PLANNING & ZONING COMMISSION

Wednesday, June 15, 2022, 10:00 AM

AGENDA

SITE PLAN

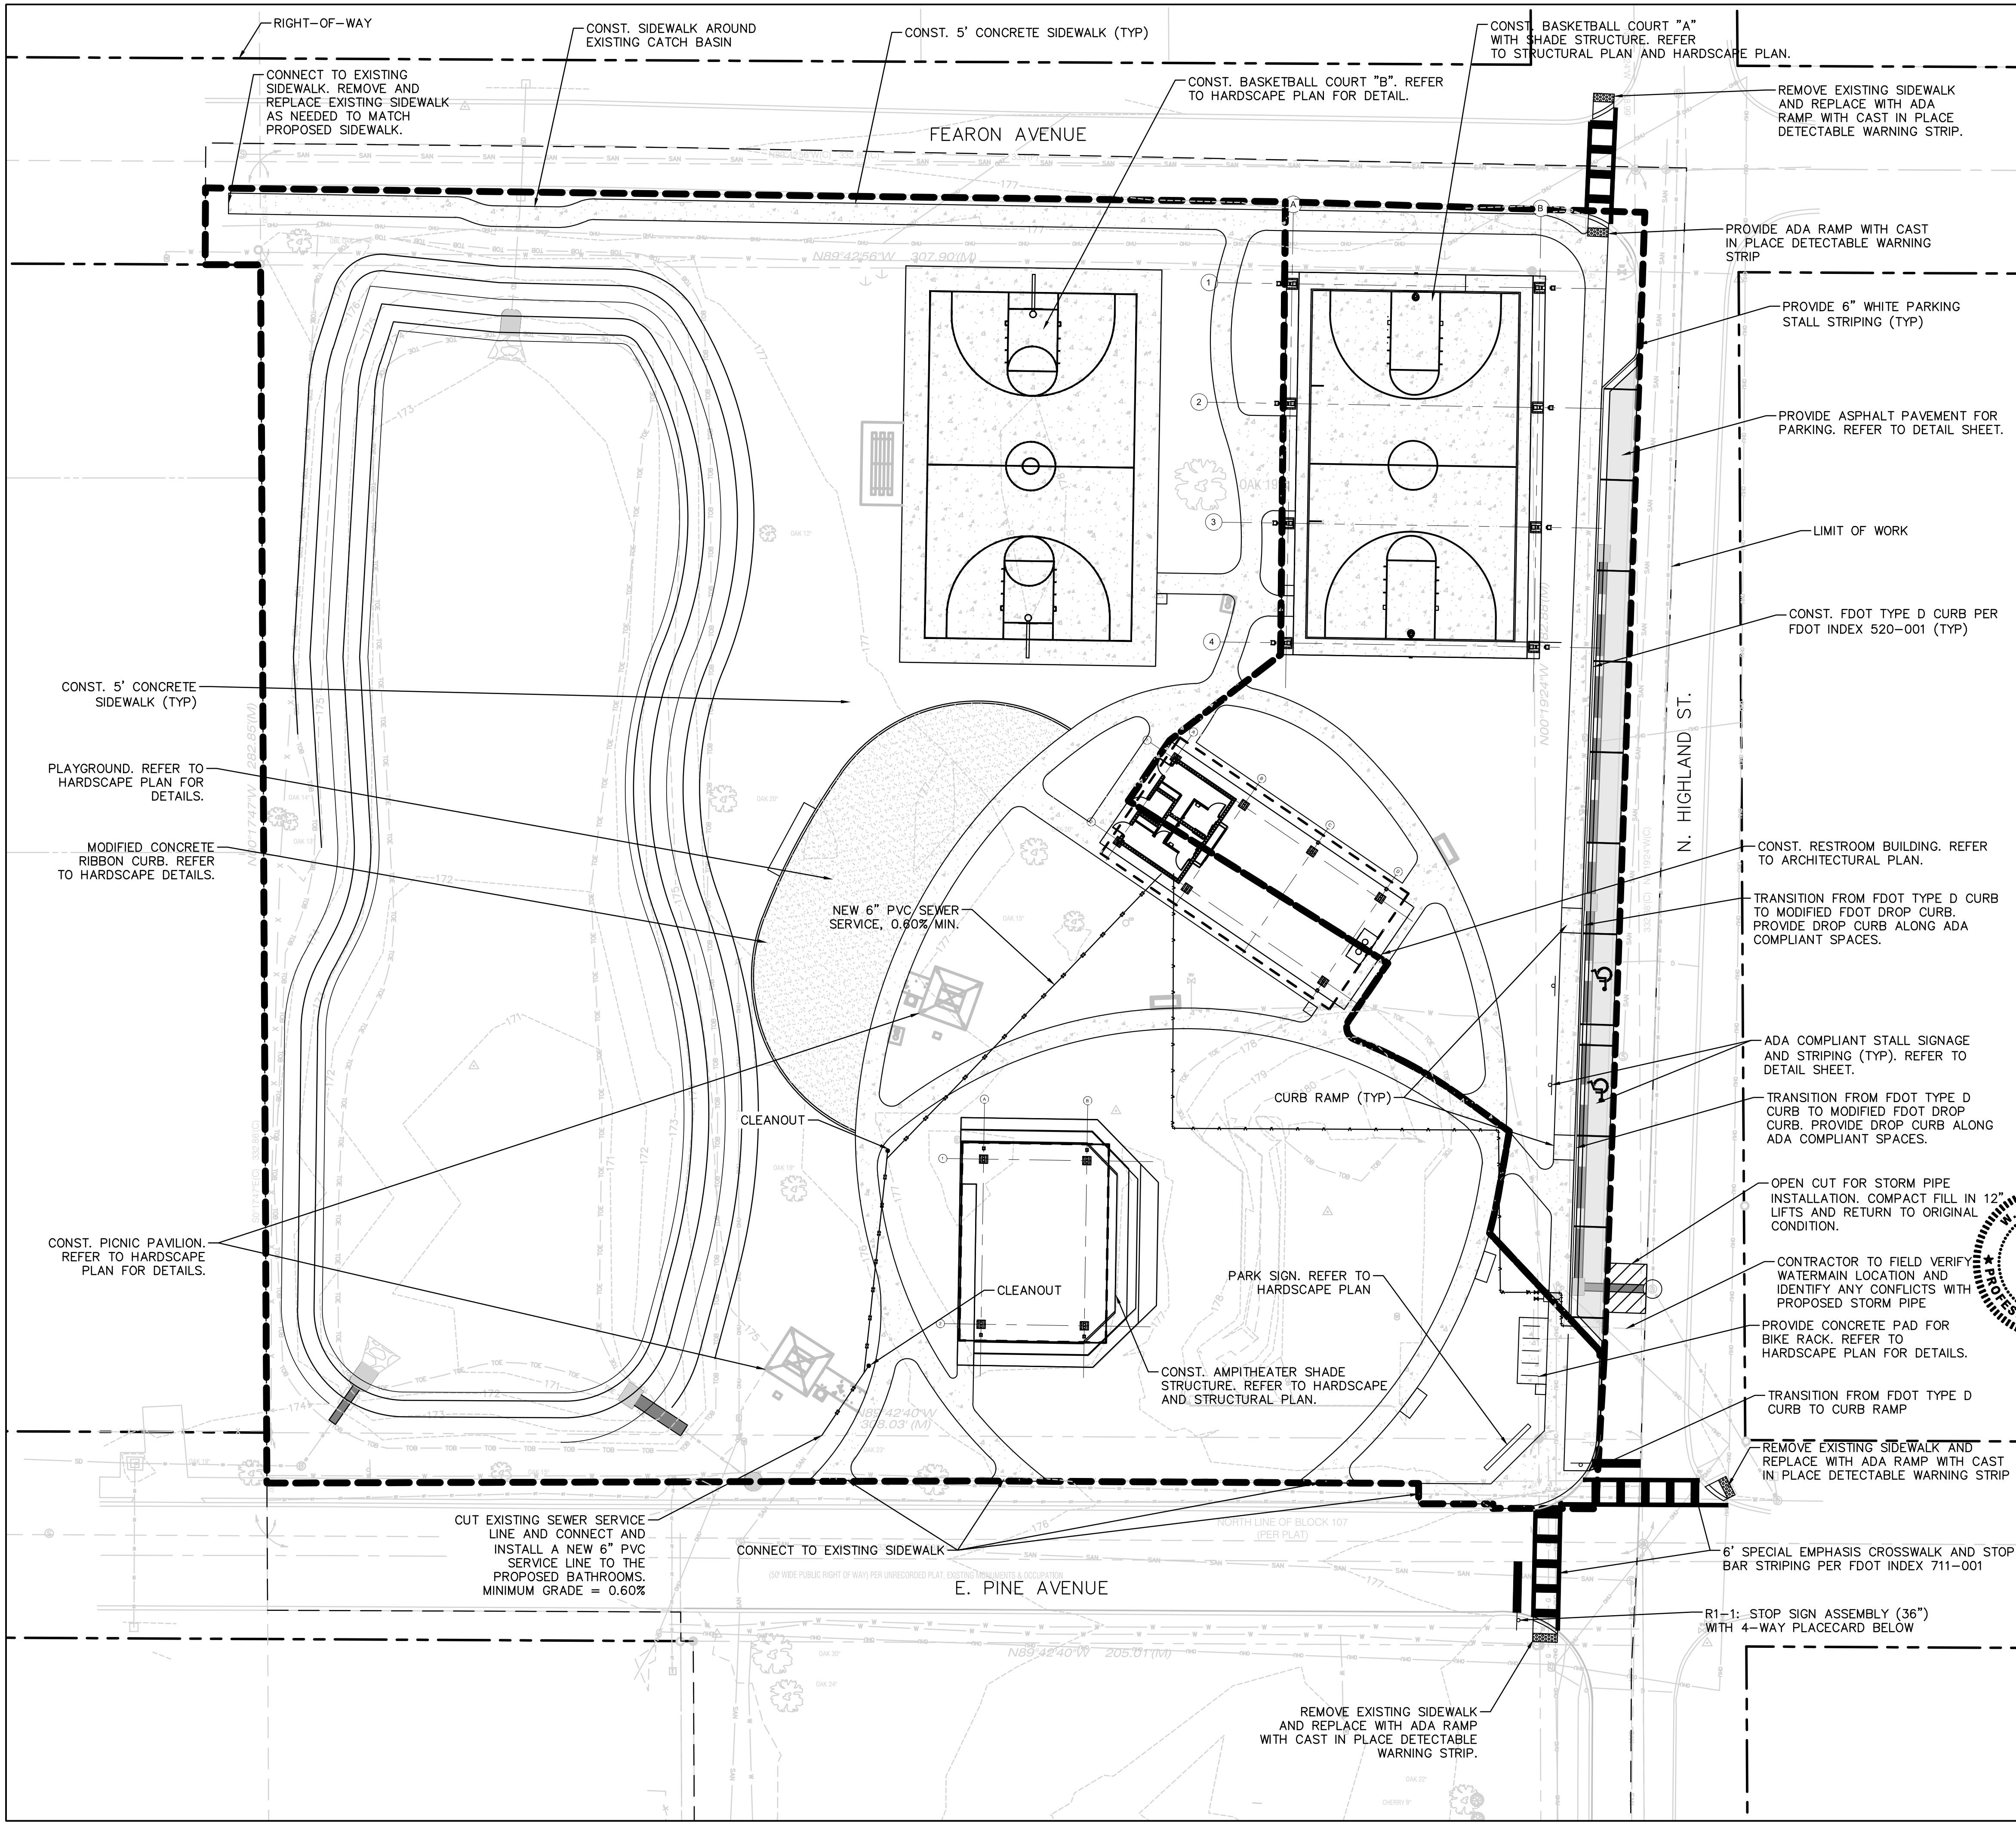
1. Plan Sheet C-000. Utility provider for electric is listed as "City of Leesburg." Electric provider in this area is the City of Mount Dora Electric.
2. Plan Sheet C-102. The potable water service from the meter and point of connection to the existing building is shown shaded back indicating that the line is to remain. Plan sheets C-201 and C-401, as well as the response to comments, indicate that the existing water service and line are to be demolished and replaced. Provide changes to the plan sheets accordingly.

3. Plan Sheet C-201. The site data table needs to be updated to reflect the minor site revision (i.e., Cauley Lott Park only) and not the previous submission for the combined Cauley Lott Park and Lillie Park project.

**GRADING &
DRAINAGE PLAN**

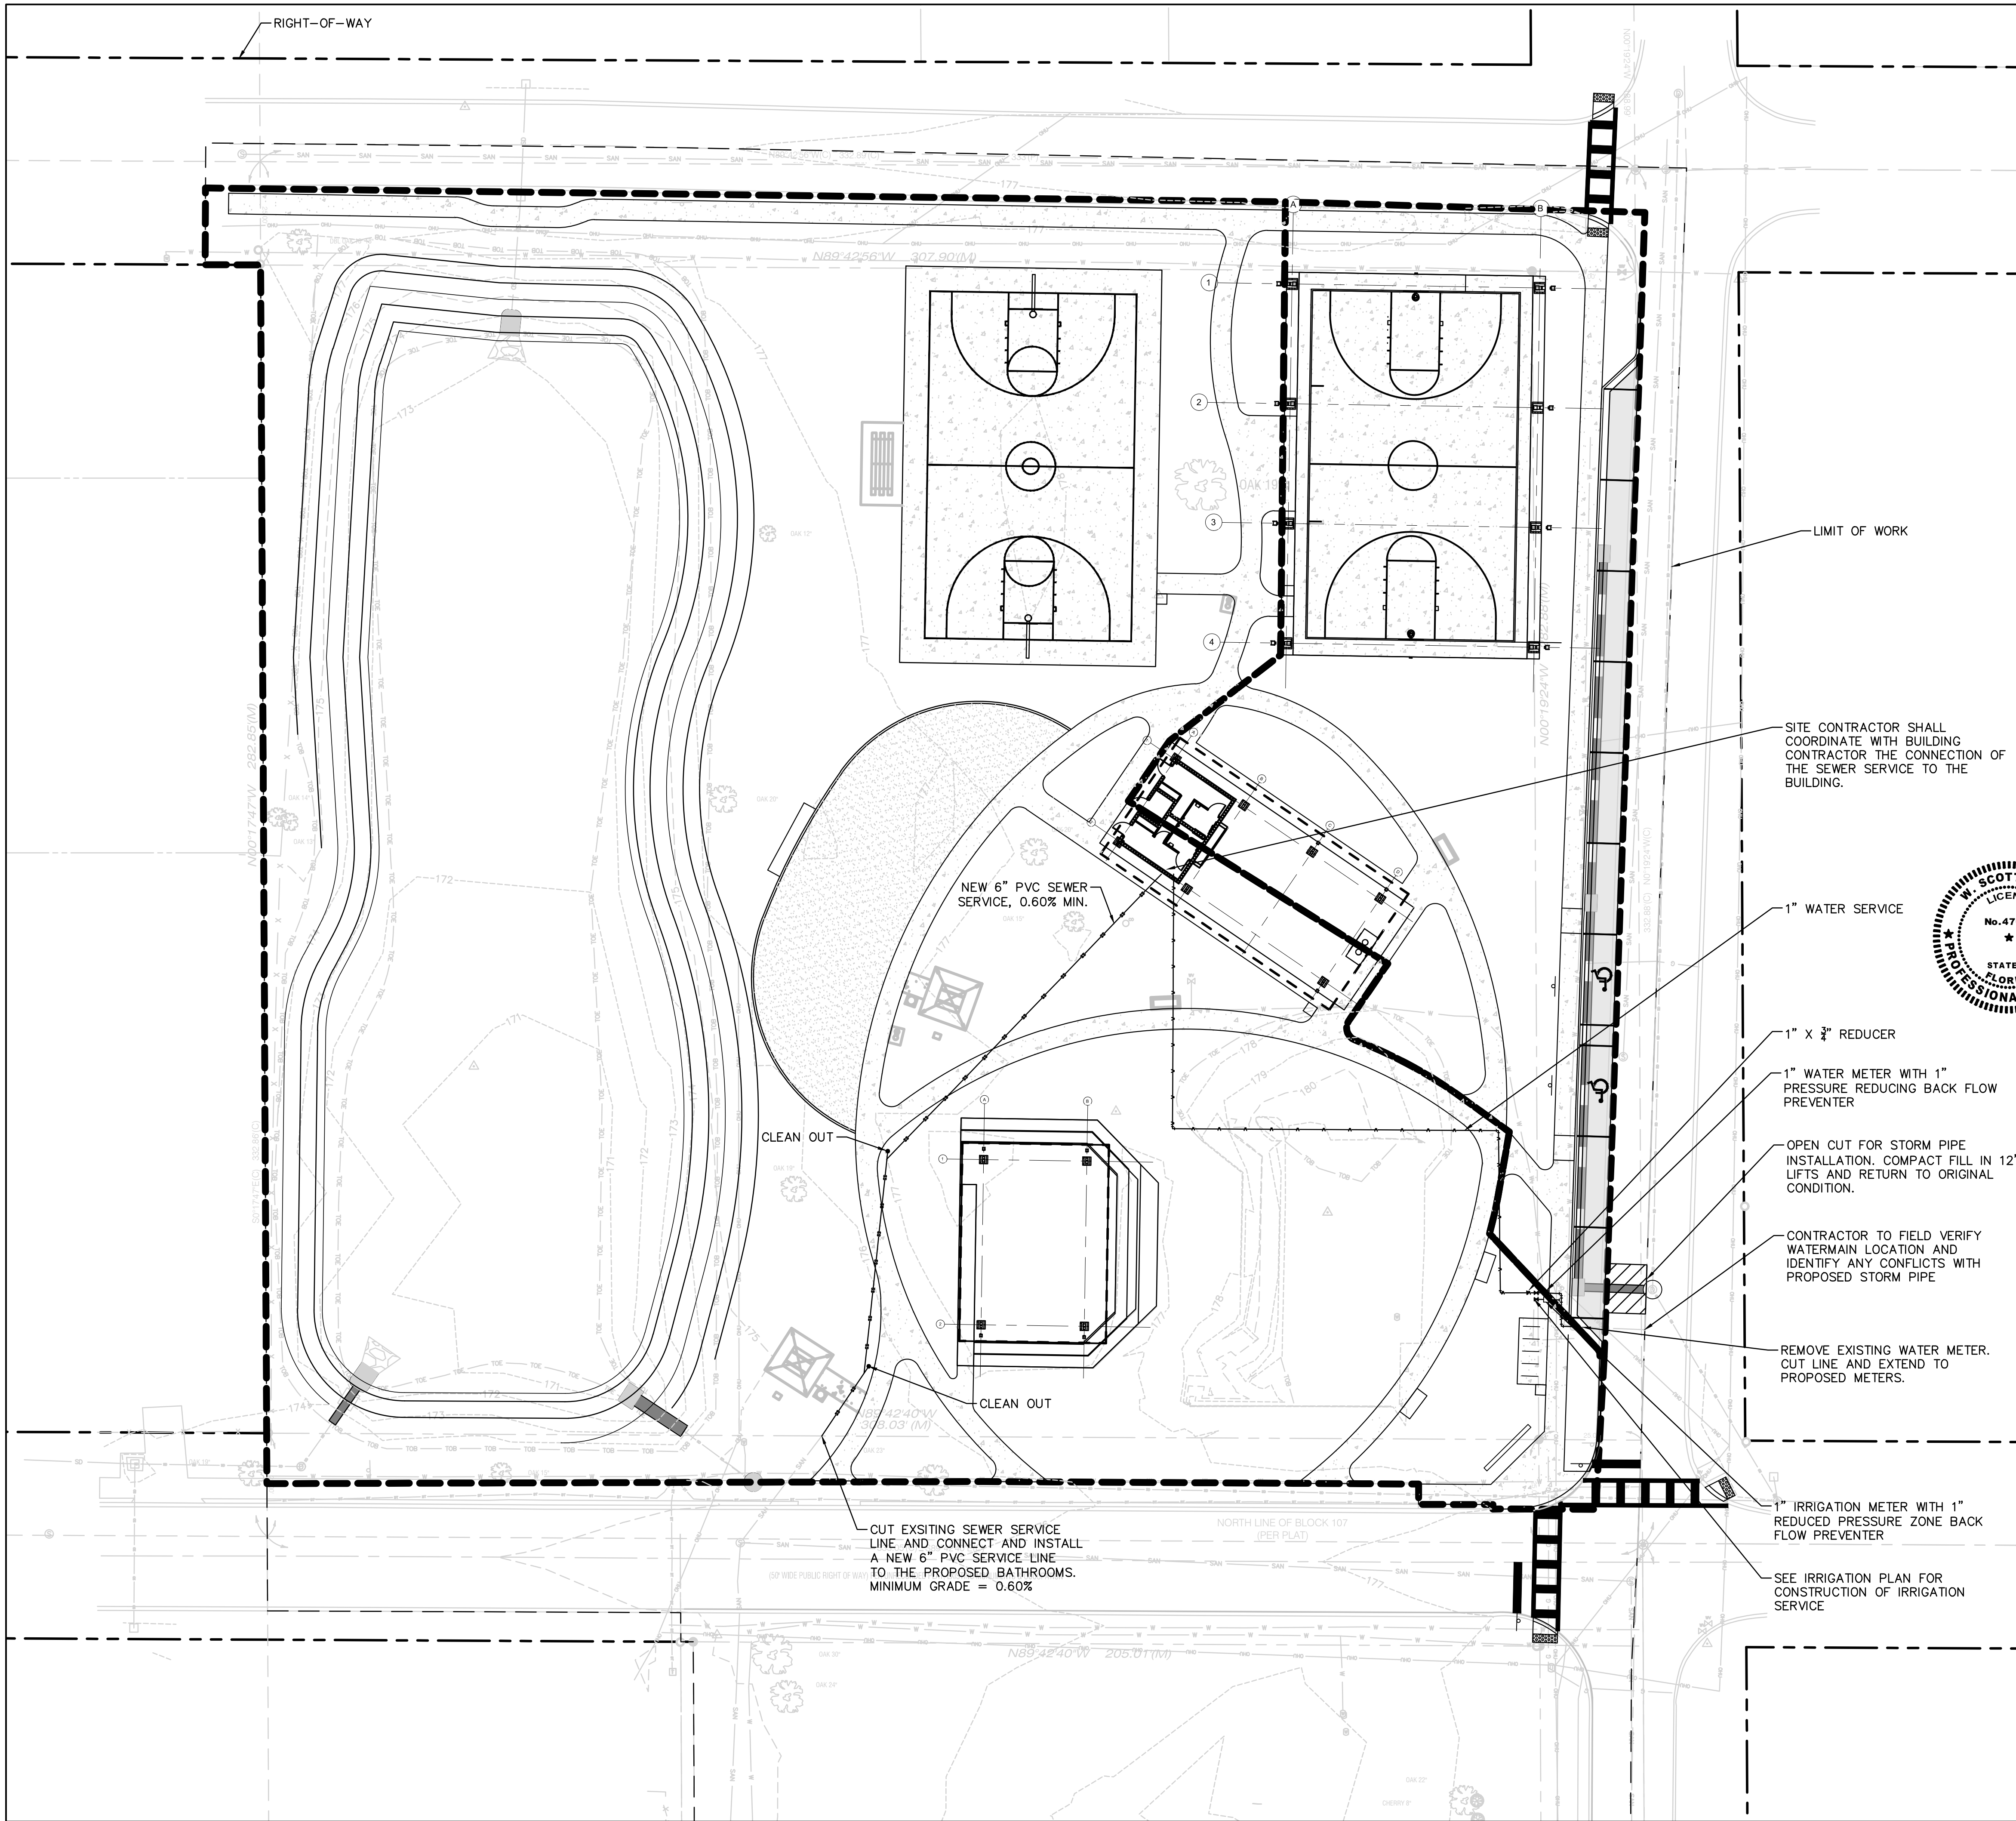
4. Plan Sheet C-201/C-401. Minimum grade on the 6" sanitary sewer line is shown as 0.60% slope. Provide for a minimum slope of 1.0% for the 6" sanitary line or upgrade to 8" diameter pipe.

5. Plan Sheet C-201/C-401. Provide elevation data for all proposed cleanouts. The new 6" sanitary line should be extended to the proposed point of connection and a cleanout provided at the property boundary. A cleanout should also be provided at the connection point to the building.
